UNITED STATES PATENT AND TRADEMARK OFFICE

APPLICATION NO.	FILING DATE	FIRST NAMED INVENTOR	ATTORNEY DOCKET NO.	CONFIRMATION NO.
10/725,957	12/02/2003	Jeffrey L. Sands	60246-299	2885

Office Action Summary

DETAILED ACTION

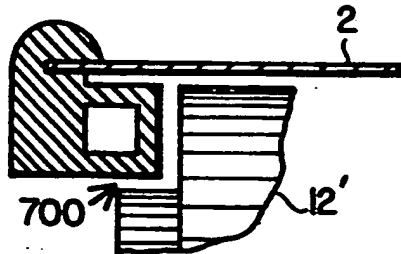
4. Claims 1, 2, and 5-9 are rejected under 35 U.S.C. 102(b) as being anticipated by Foote et al. (US Pat. 5,369,477).

See the attached marked up drawing figure 3 of Foote et al. depicting the claimed features.
